Metro Martin Place

Over Station Development Design Integrity Report North Site

JUNE 2020

MARTIN PLACE OSD DRP – SESSION 13 05.05.20

L10 eastern
terrace

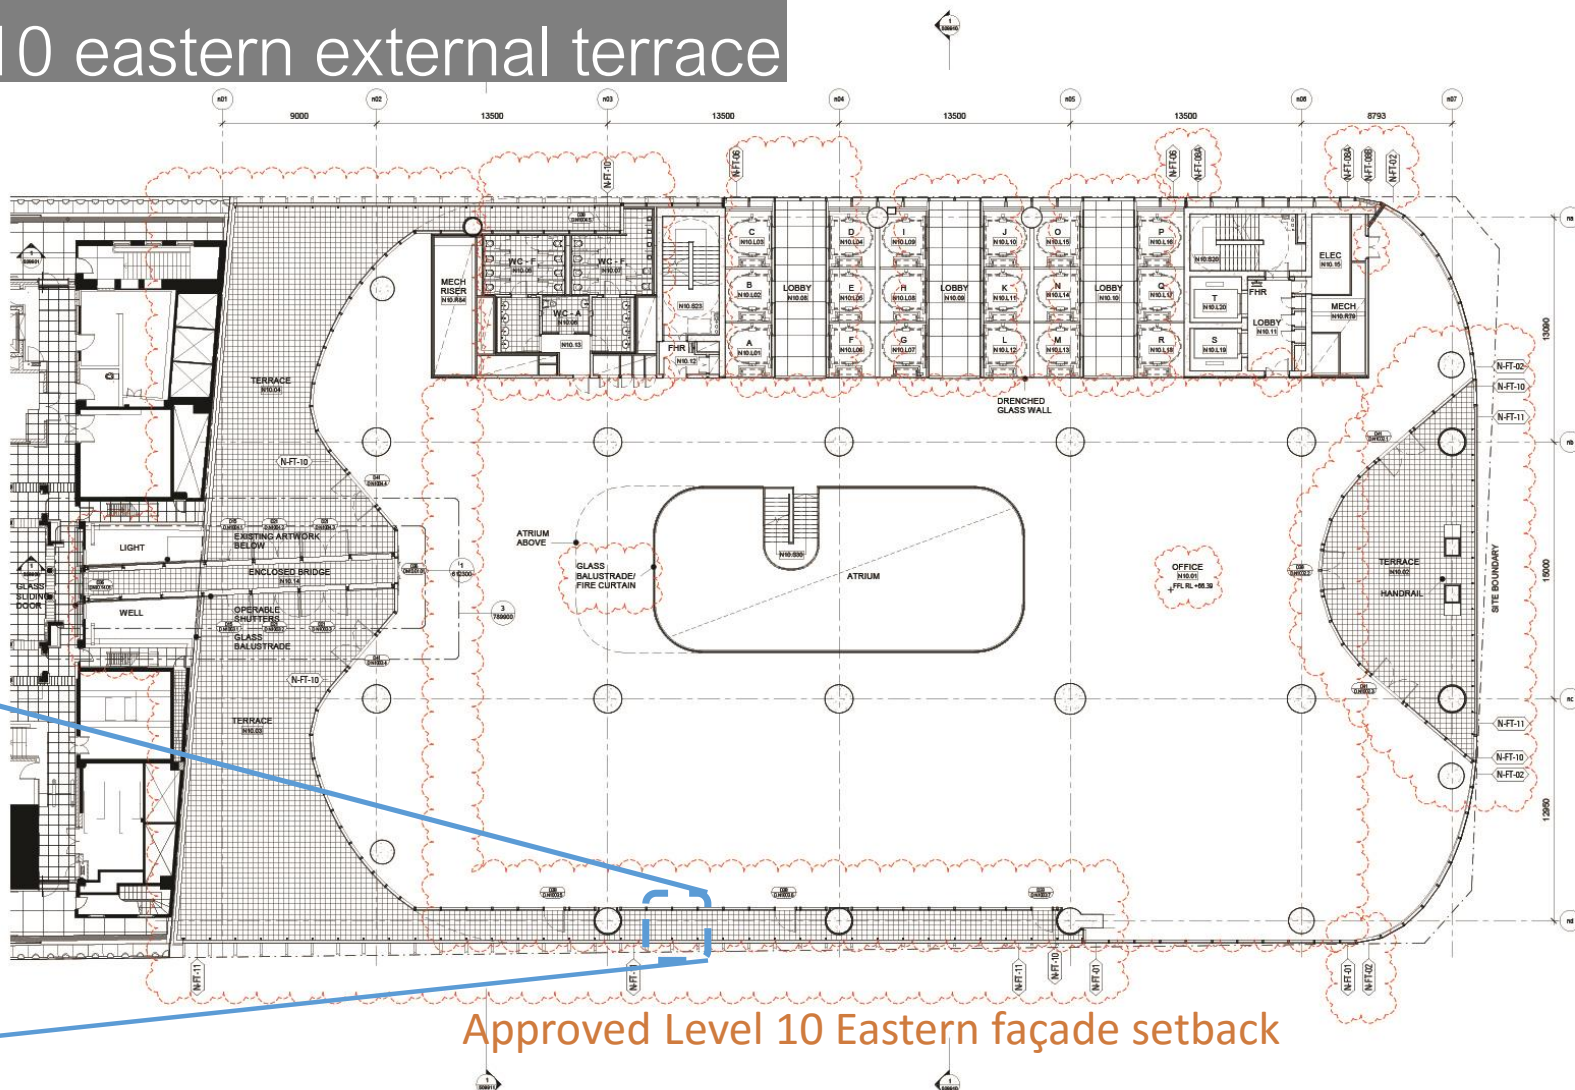
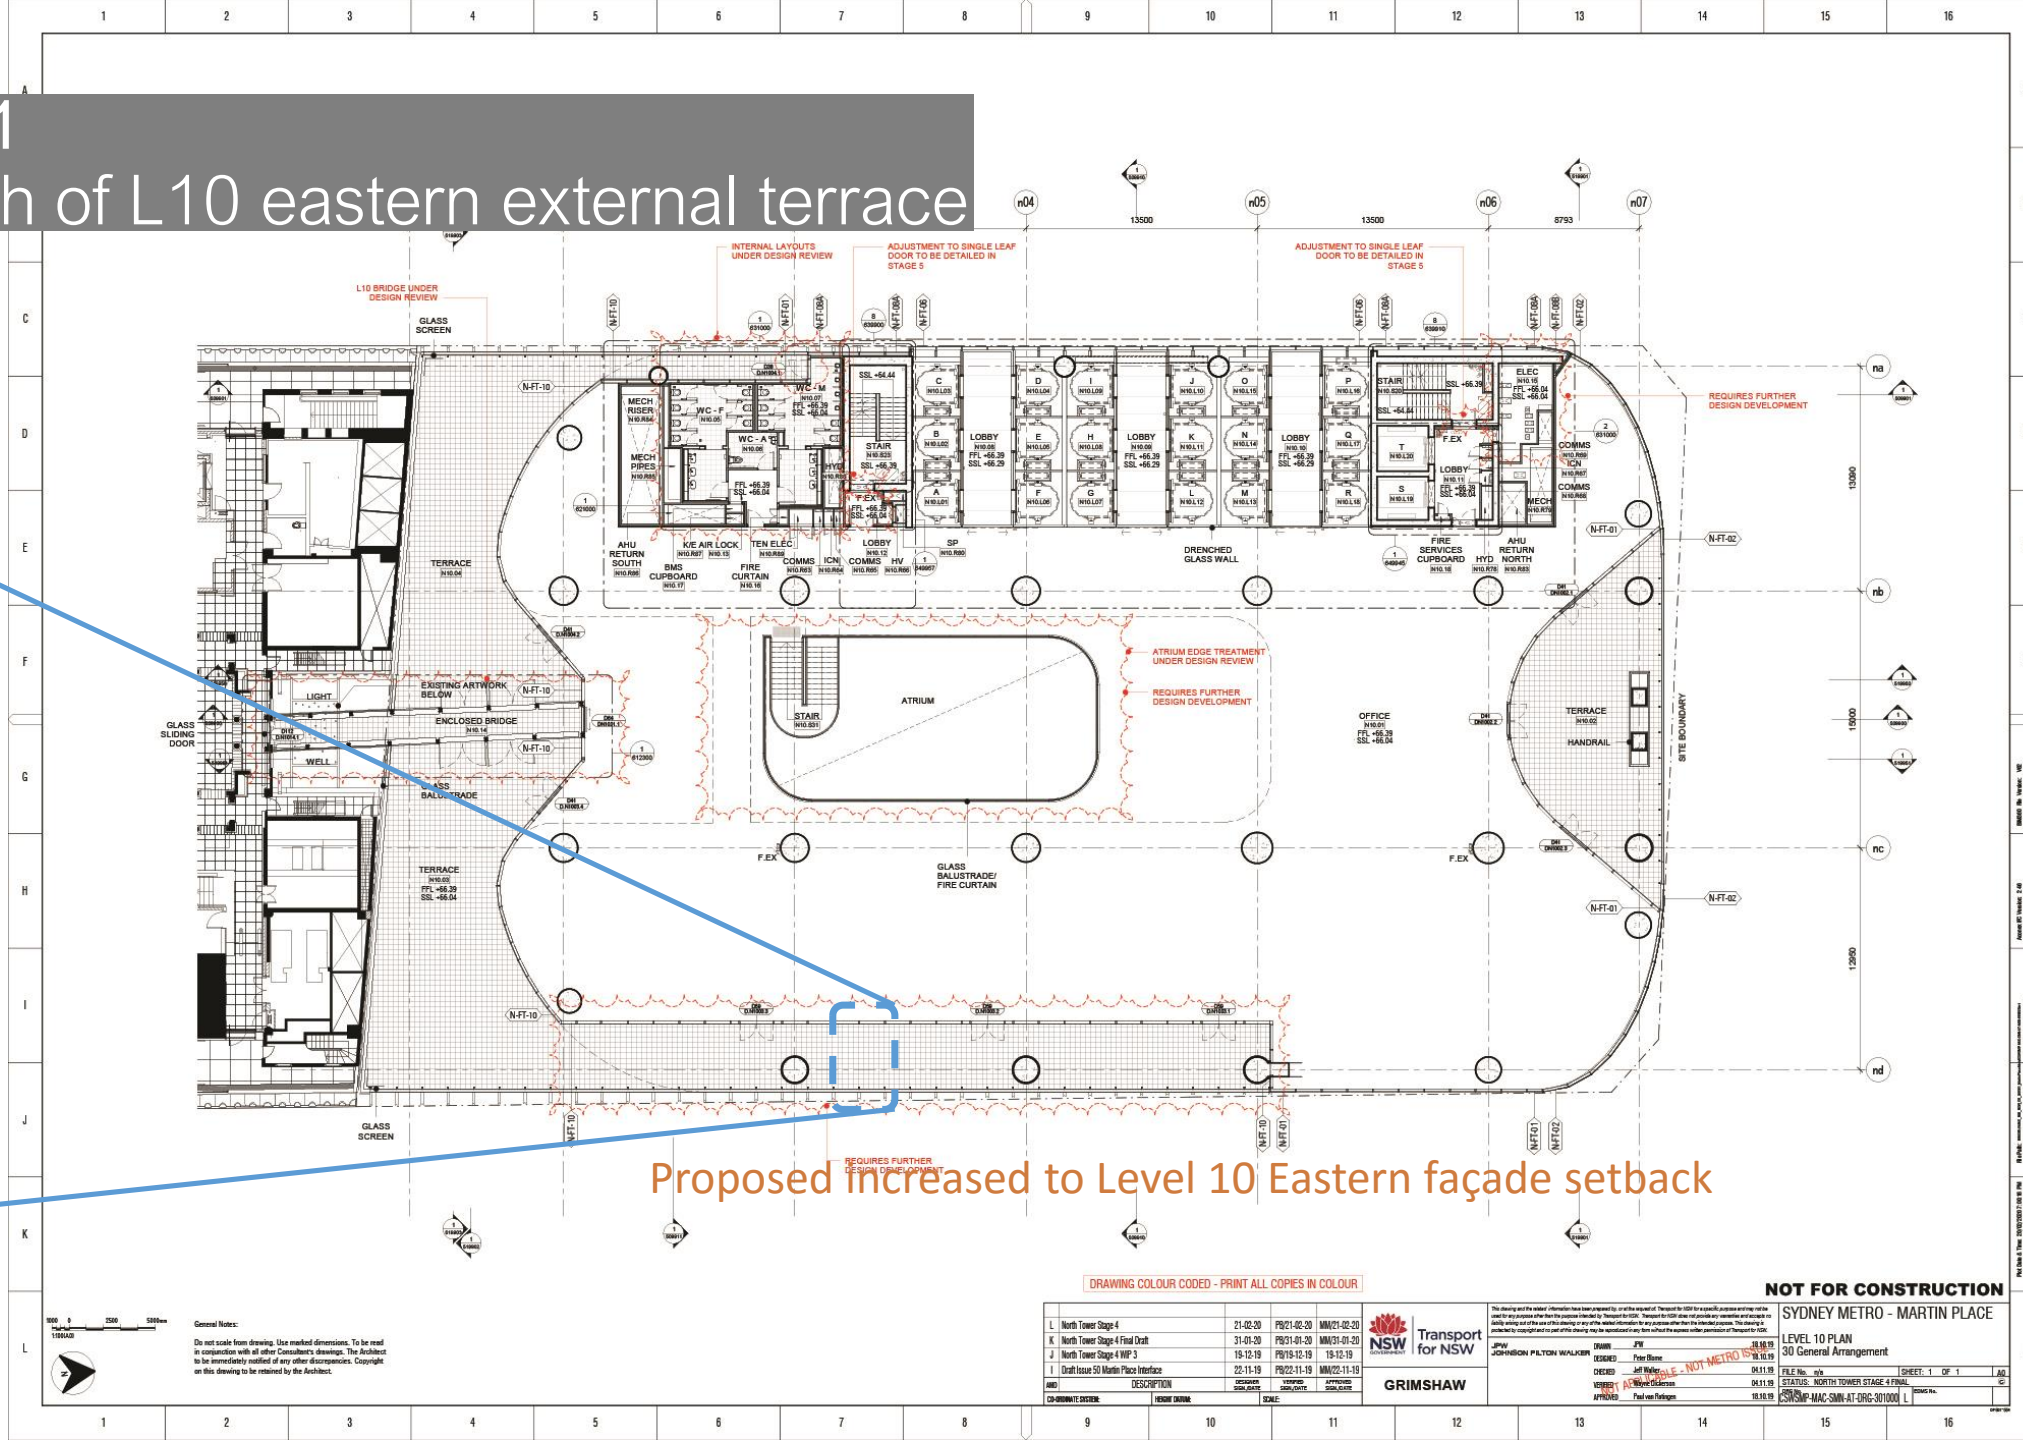
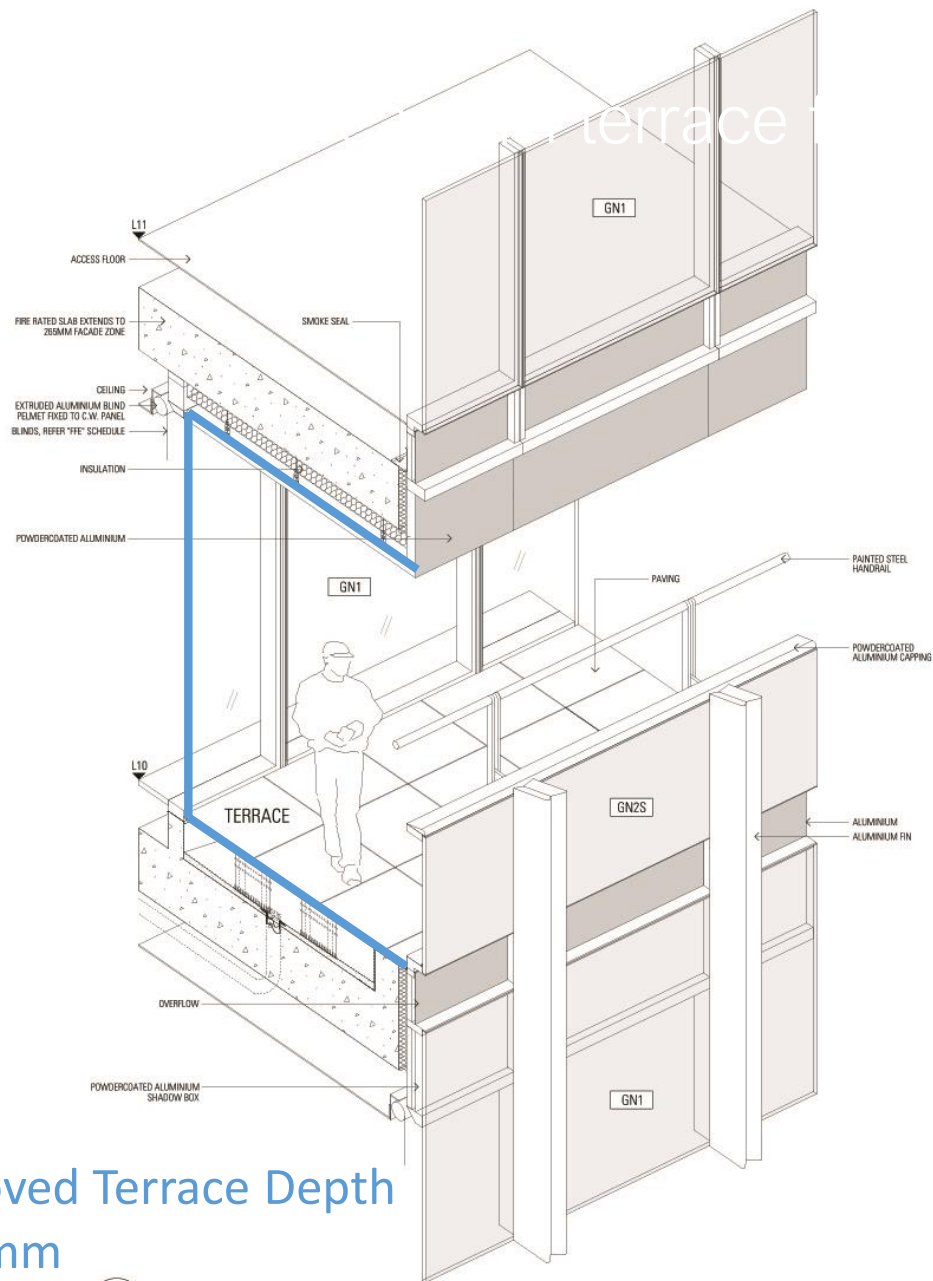
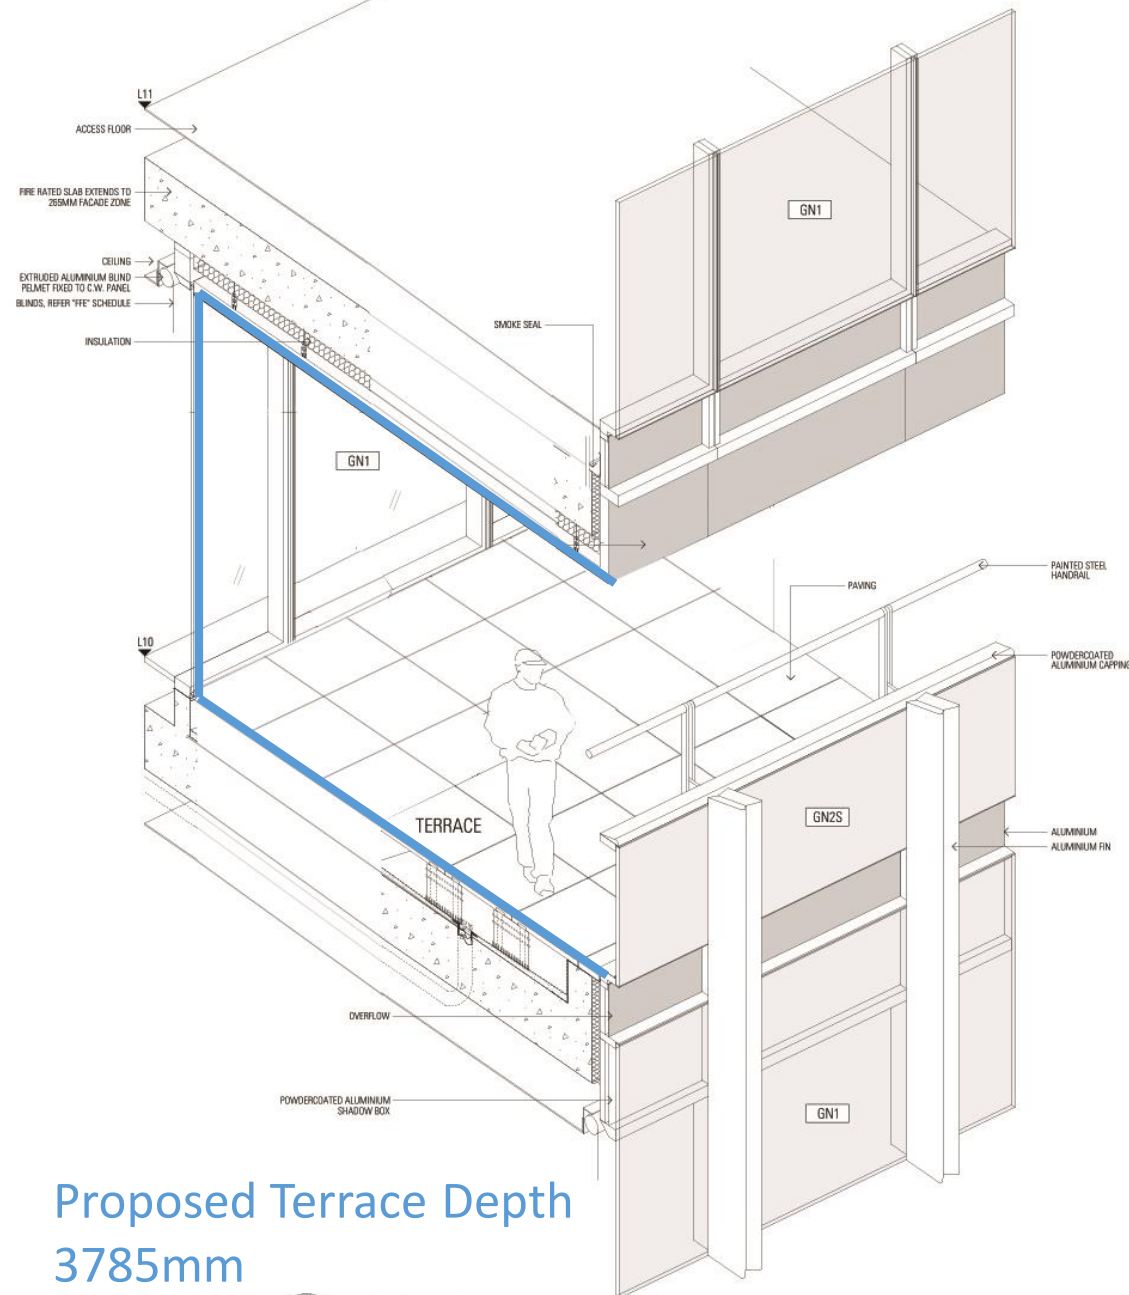
Proposal
L10 eastern façade setback
3785 mm

Approved Terrace Depth
1835mm

Proposed Terrace Depth
3785mm

L03 Current Configuration – Floor/Façade Junction (L04 Similar)

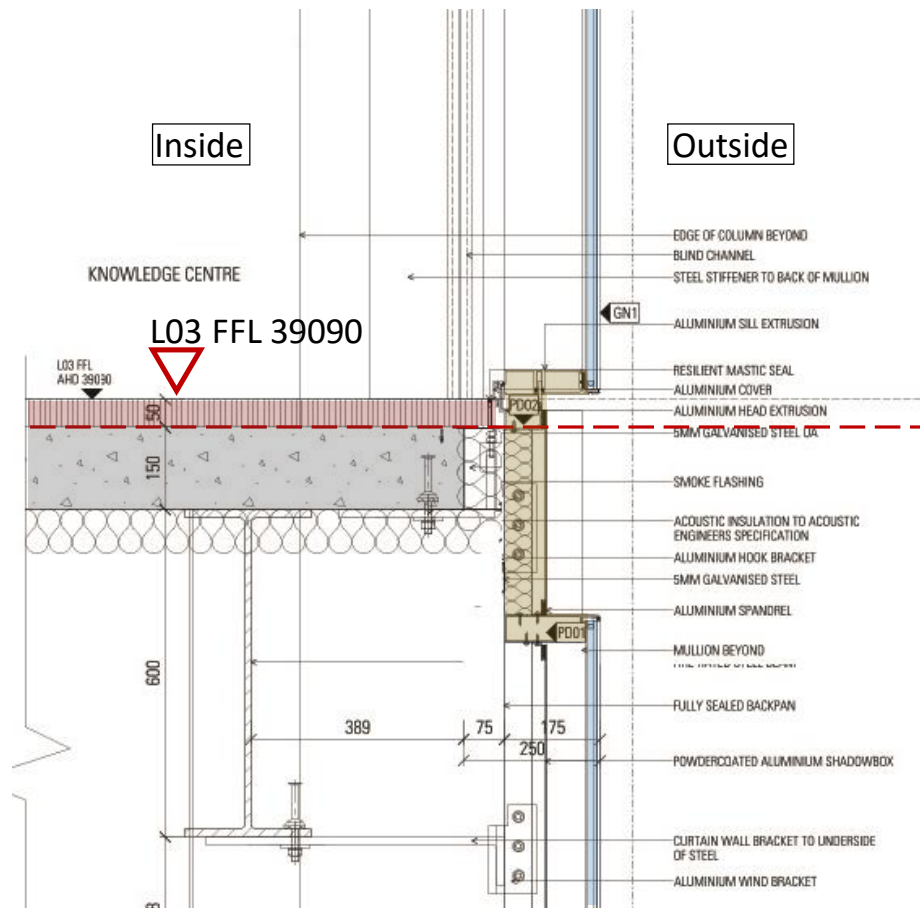
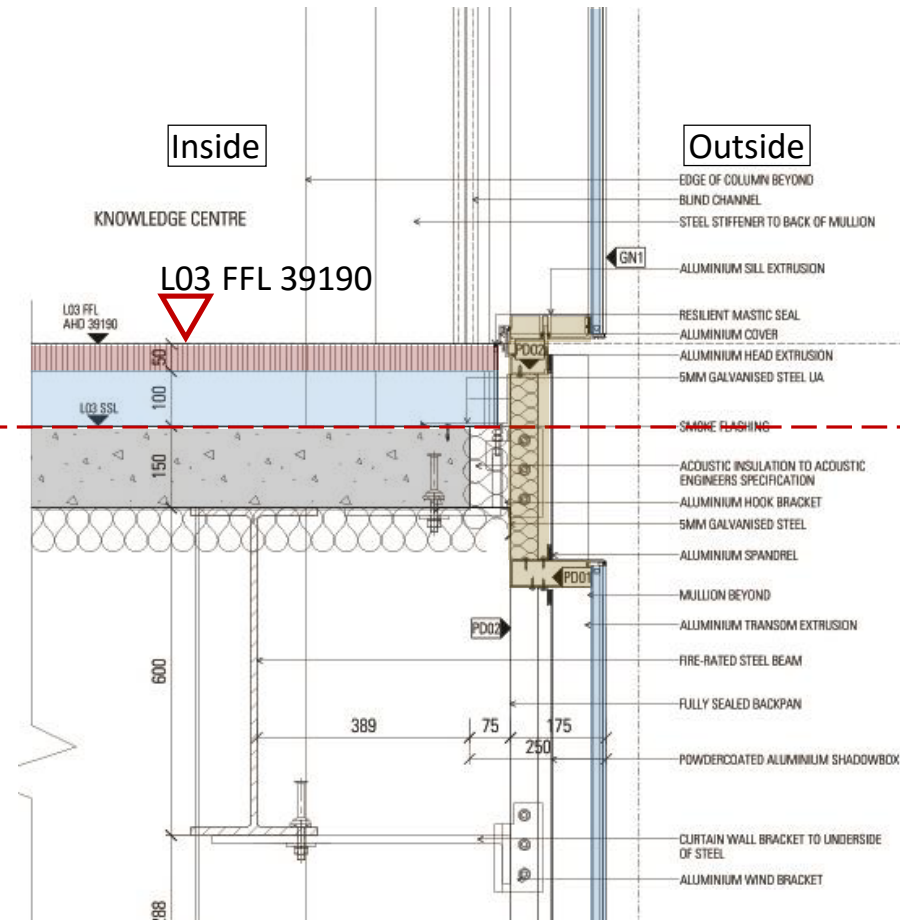
Proposed L03 revised configuration – Floor/Façade Junction (L04 Similar)

L03 SSL 39040
(No change)
